STATE OF NORTH CAROLINA
DEPARTMENT OF TRANSPORTATION

SUBJECT: Lee County, US 421-NC 87 Sanford Bypass; From existing US 421 northwest of Sanford to existing NC 87 southeast of Sanford; T.I.P. Number R-2417C; Federal Aid Project No. STPNHF-421(2); State Project 8.T540402

Subject: Action ID No. 2002-20899, TIP No. R-2417C, U.S. 421/NC 87 from east of NC 42 to NC 87 near SR 1138, Lee County, North Carolina.

Subject: Sixth Modification to the 401 Water Quality Certification Pursuant to Section 401 of the Federal Clean Water Act with ADDITIONAL CONDITIONS for the US 421/NC 87 (Sanford Bypass) from East of NC 42 to NC 87 near SR 1138 in Lee County, Federal Aid Project No. STPNHF-421(2), State Project No. 8.T540402, TIP R-2417C, DWQ Project No. 00-1432

Permit Drawing
 Sheet **14** of **31**

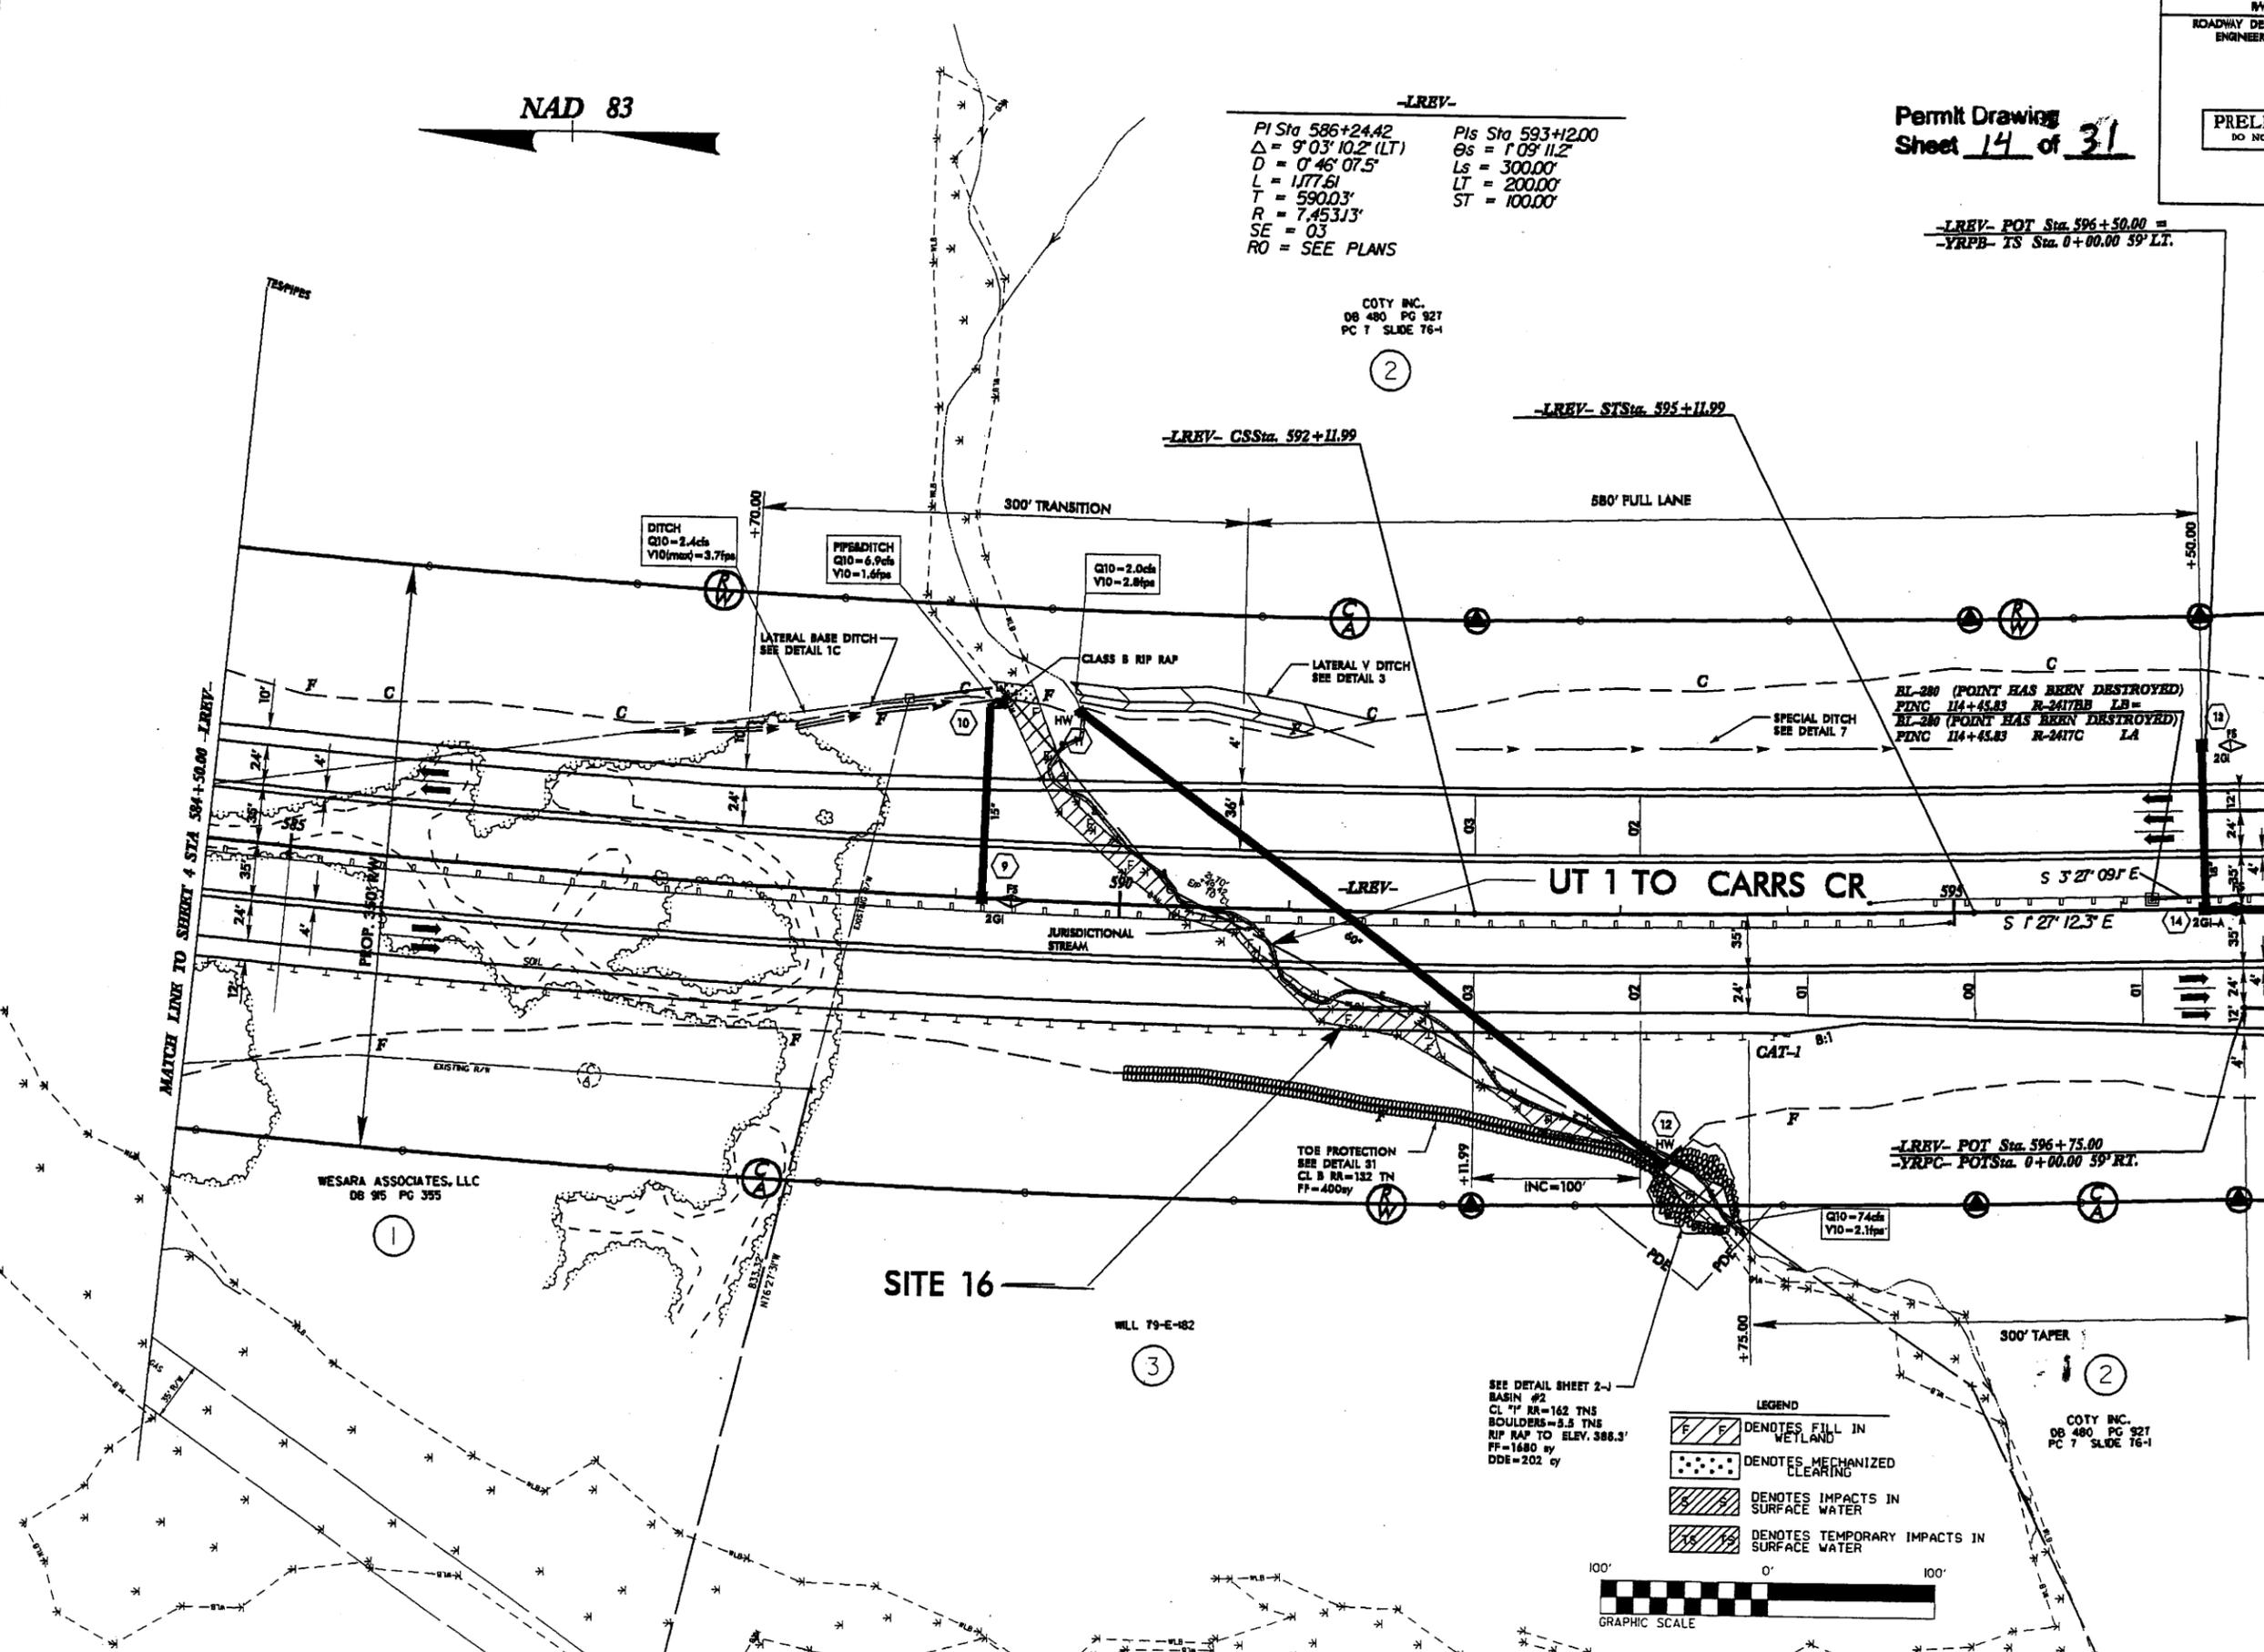
1. The natural rock energy dissipator proposed at Permit Site #16 (Permit Drawing Sheet 14 of 31) shall be constructed per Detail Sheet 2-K. Rock used to construct the dissipator and associated "rock sill" shall be constructed so that low flow passage of water or aquatic life is impeded.

Permit Drawing
Sheet **25** of **31**

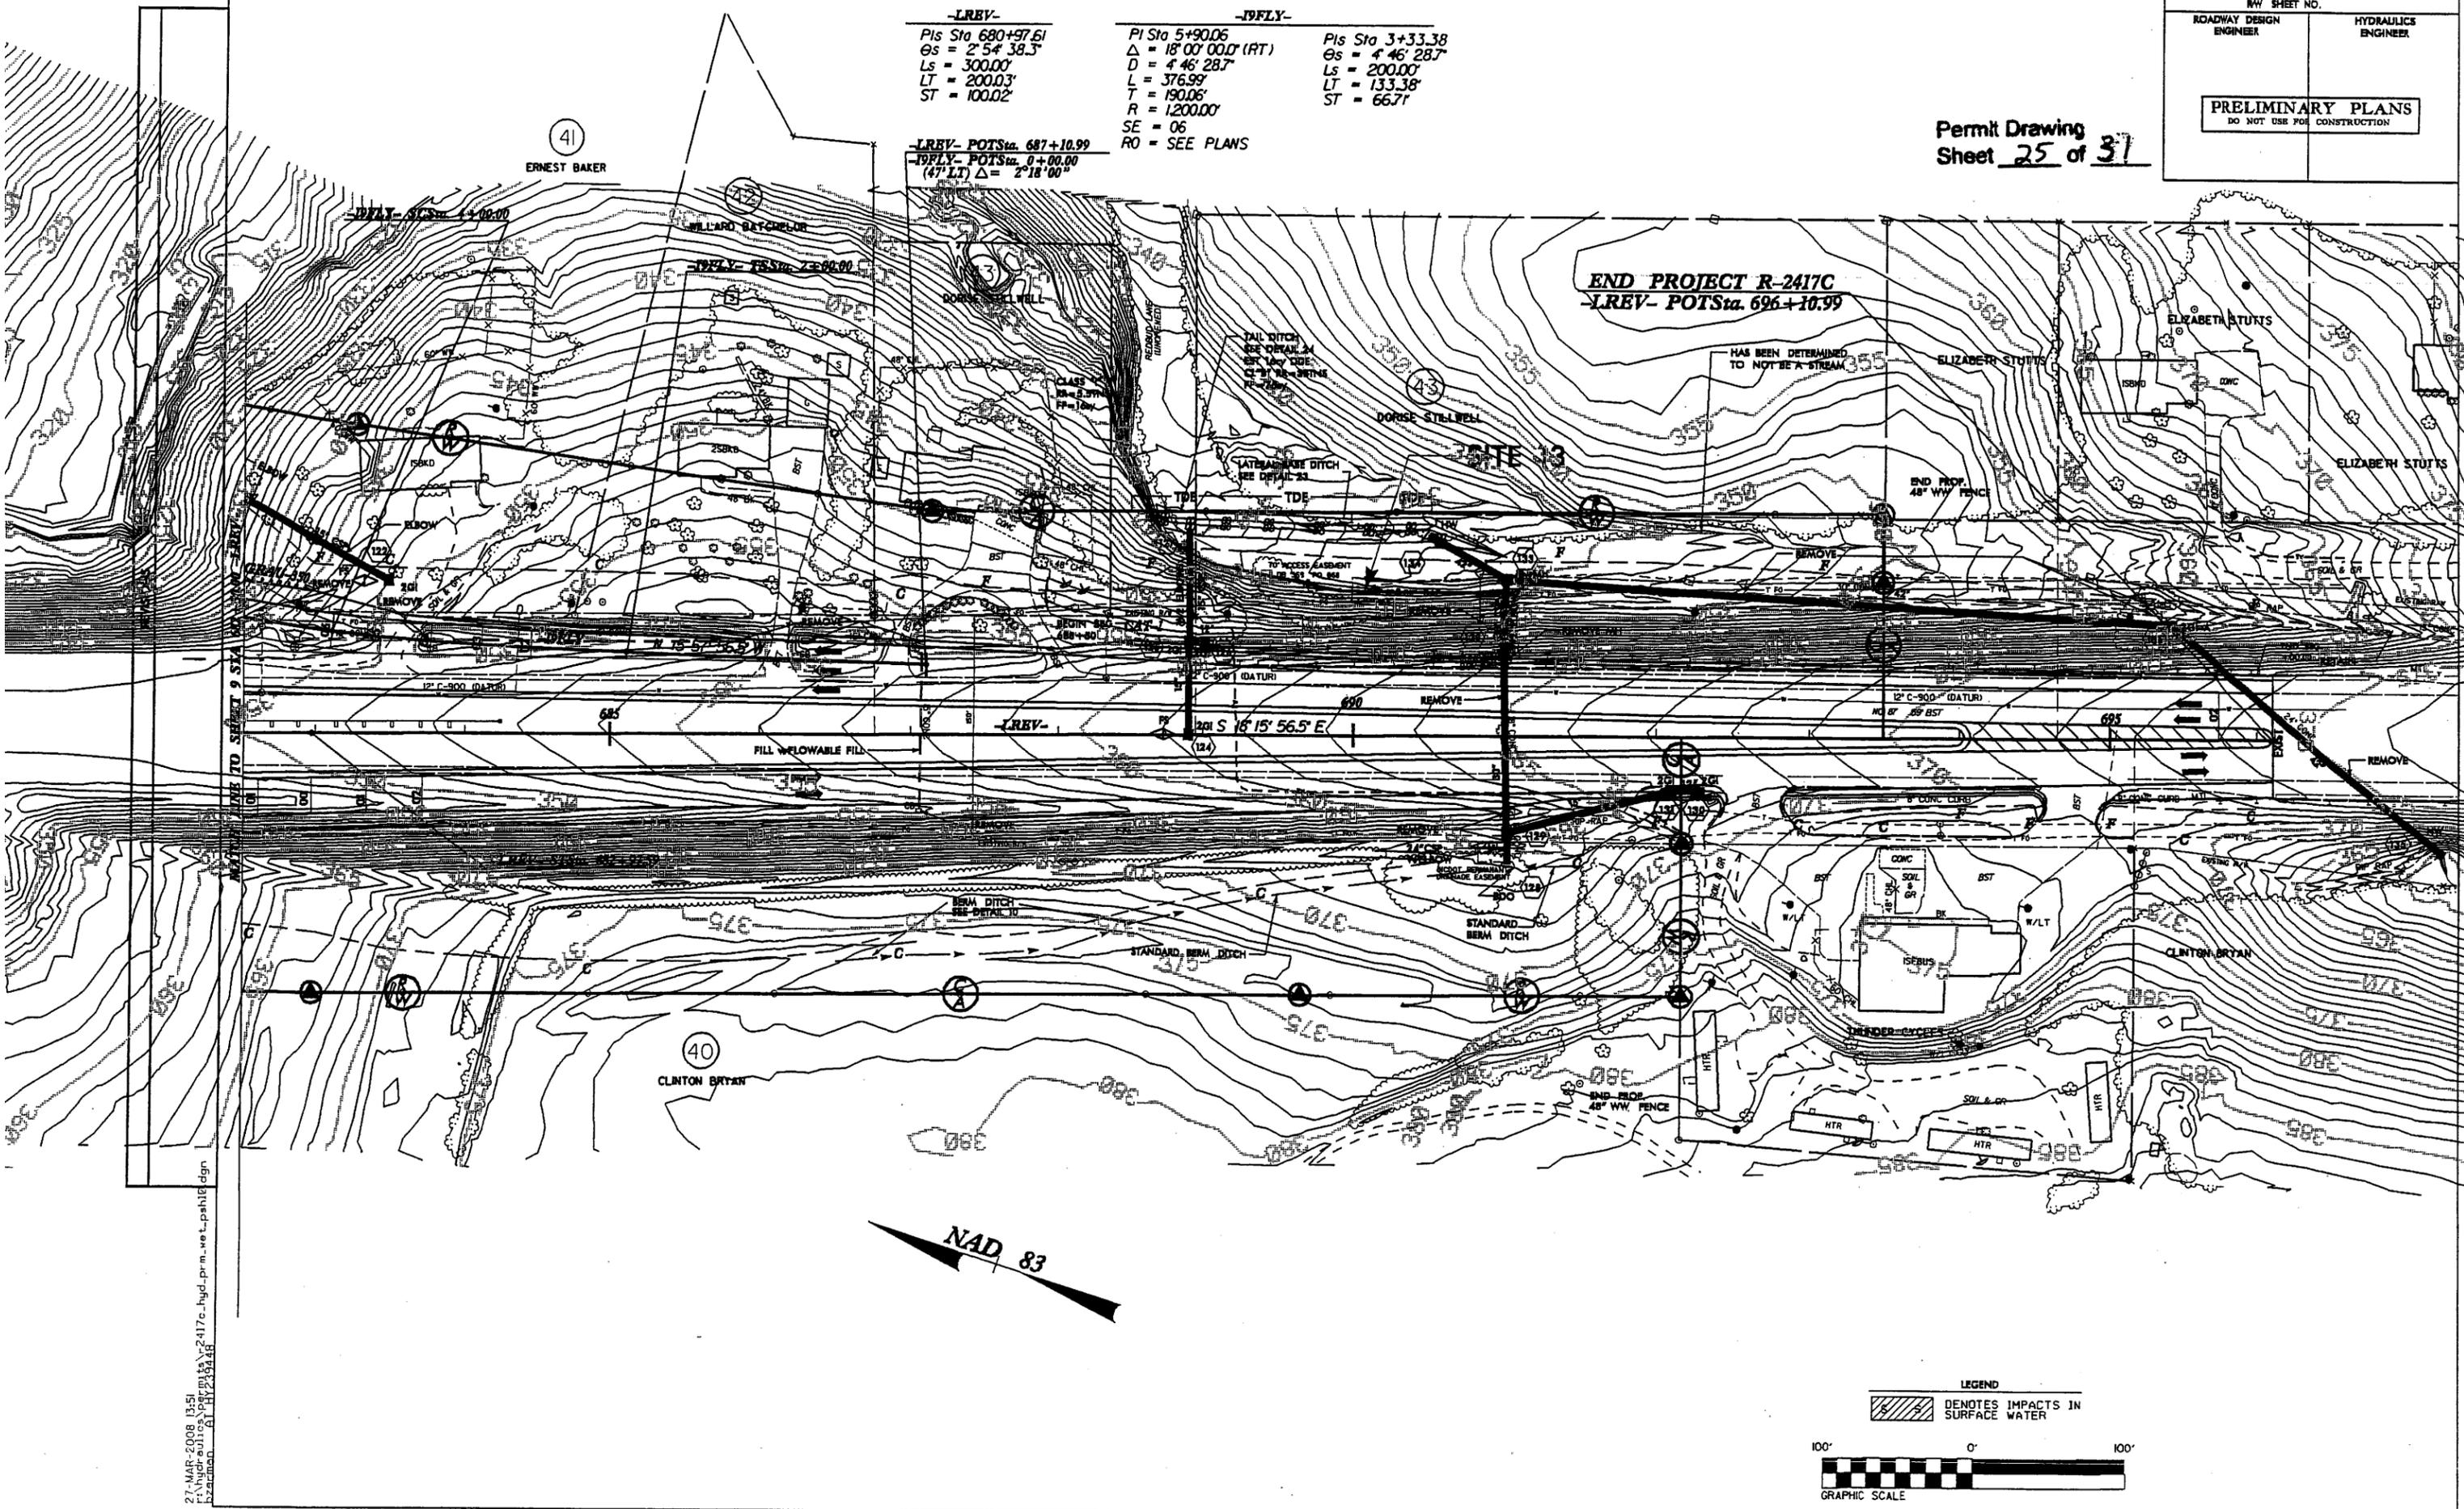
4. The stream is relocated to a ditch line at Permit Site #13 (Permit Drawing 24 of 31) and then conveyed into the natural stream. The ditch line appears to discharge to the natural stream at nearly a right angle. NCDOT is advised that if stream bank destabilization occurs as a result of the ditch line alignment, corrective actions to stabilize the stream will be required.

Permit Drawing
Sheet 30 of 31

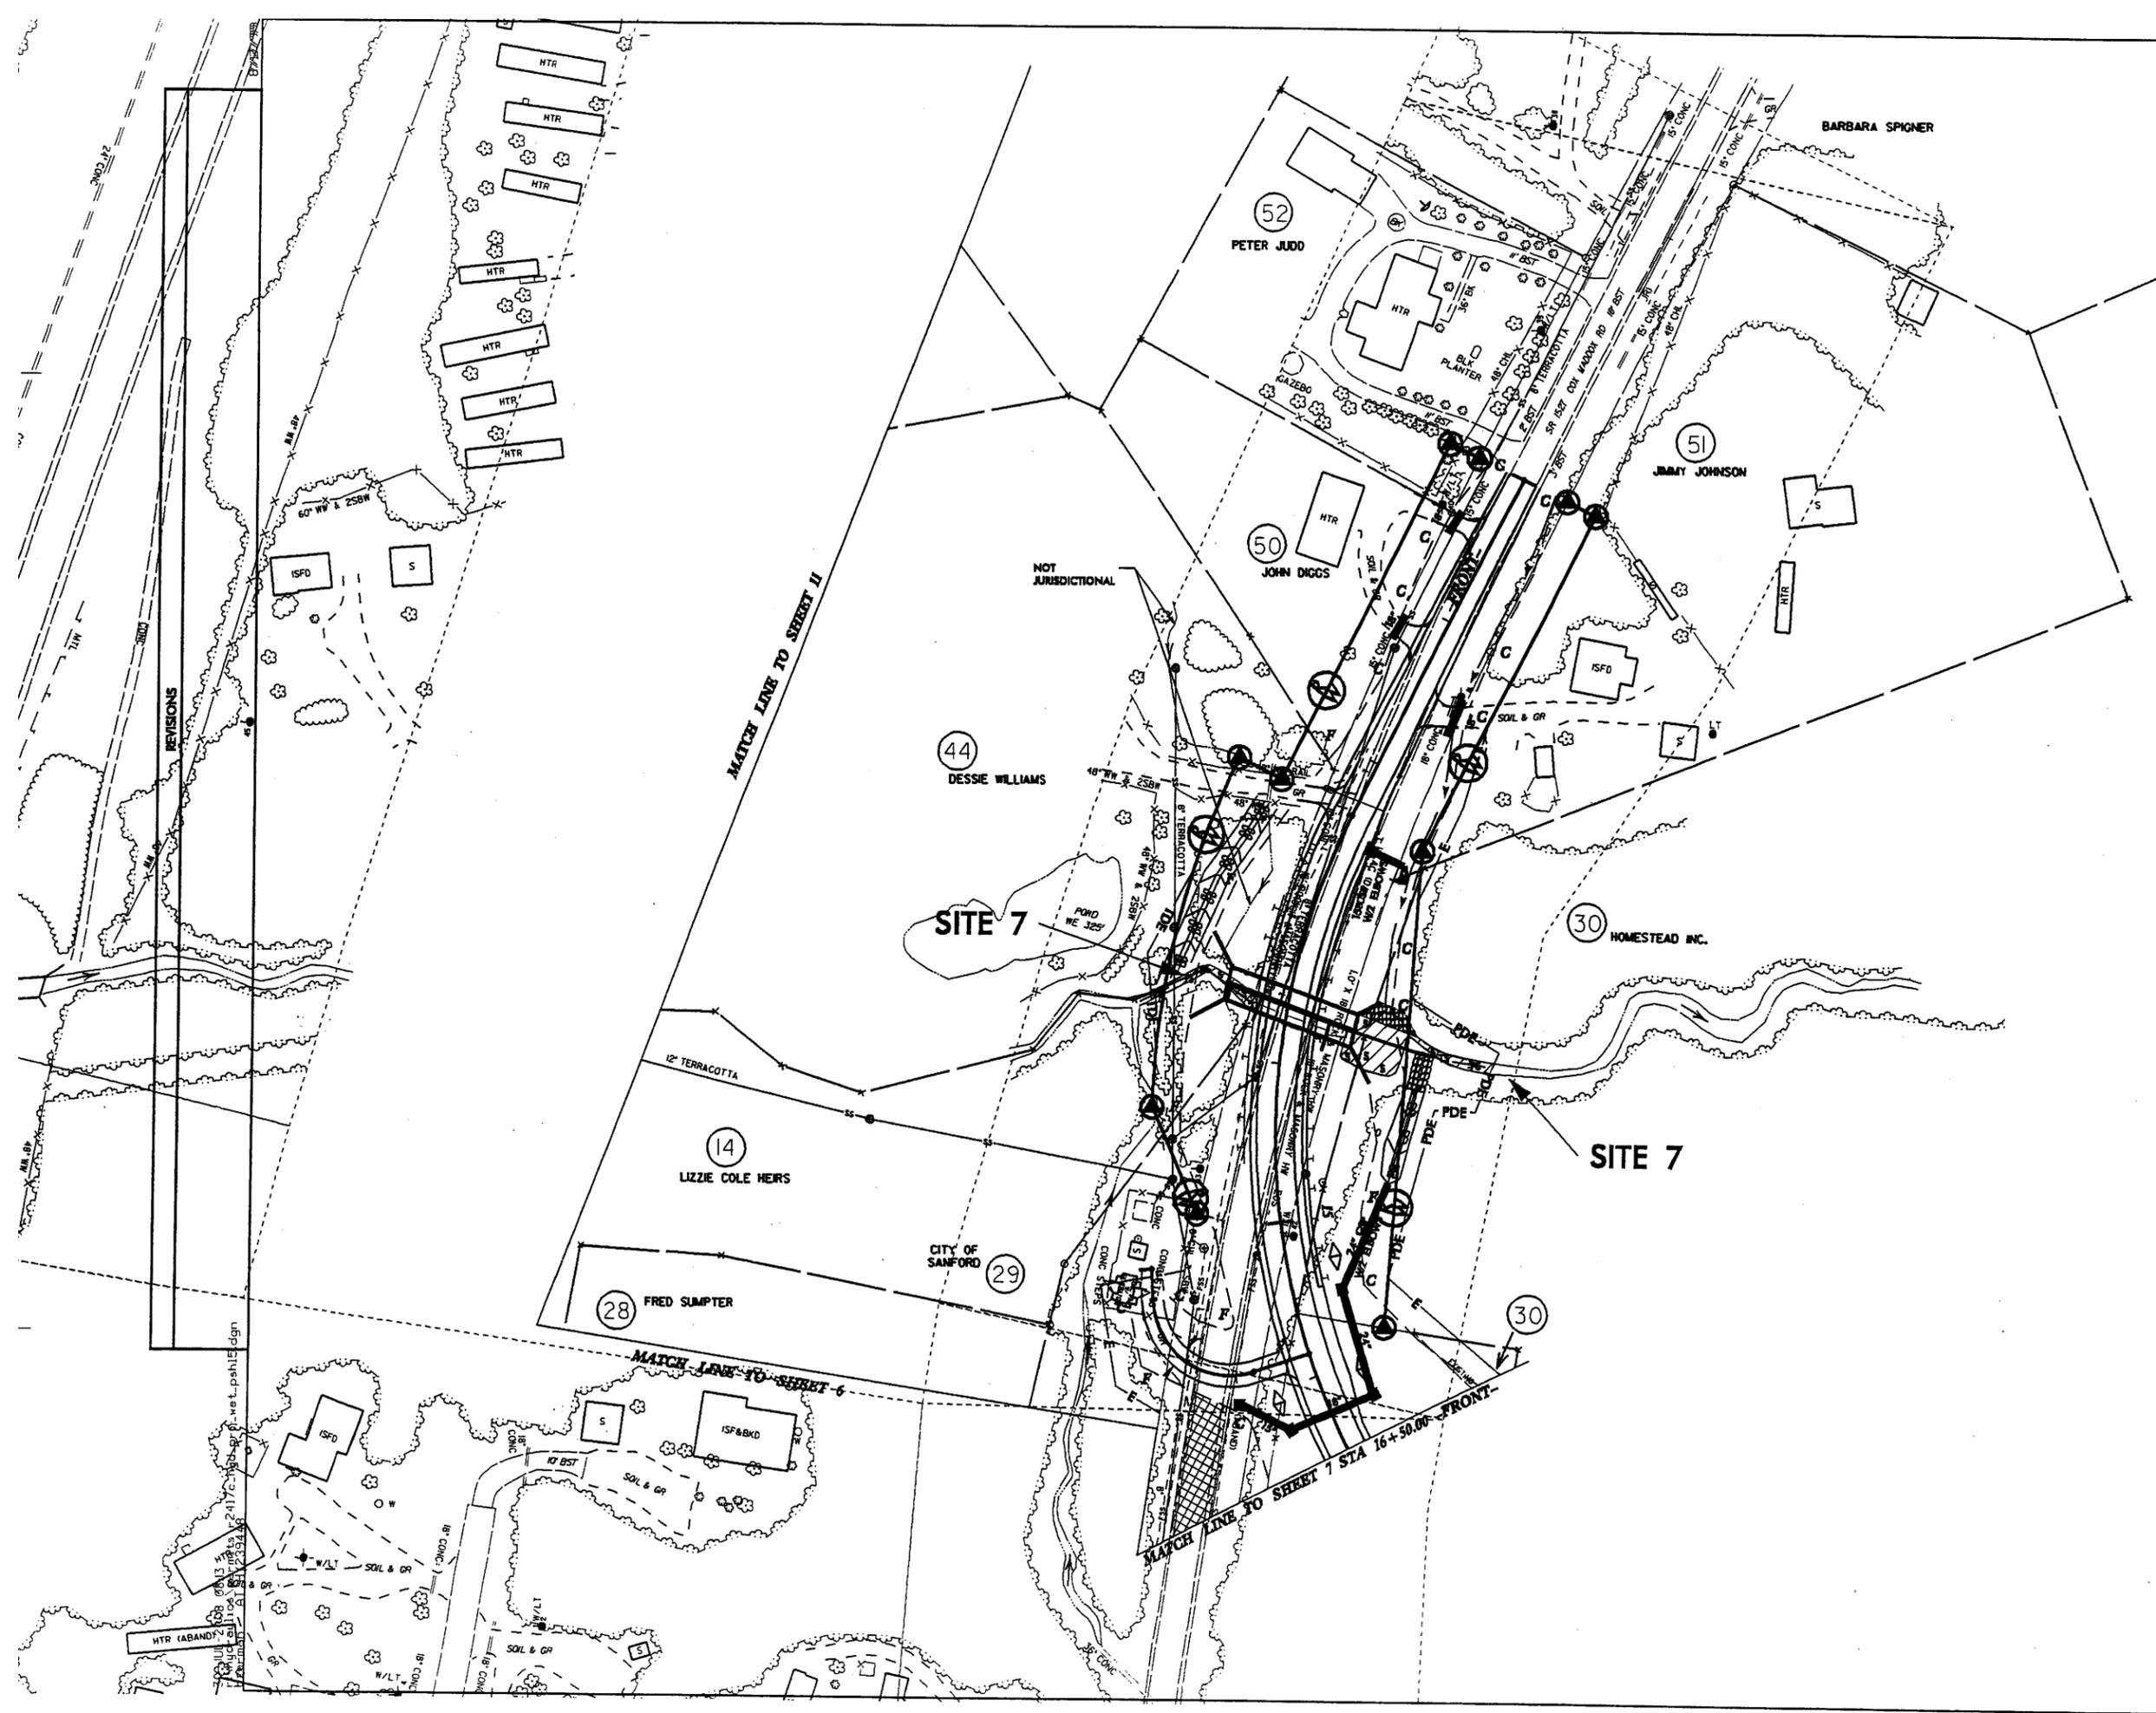
8. A sill shall be placed on one of the box culverts to maintain the natural stream dimension at Permit Sites 2 (Permit Drawing 16 of 31) and 7 (Permit Drawing 30 of 31).
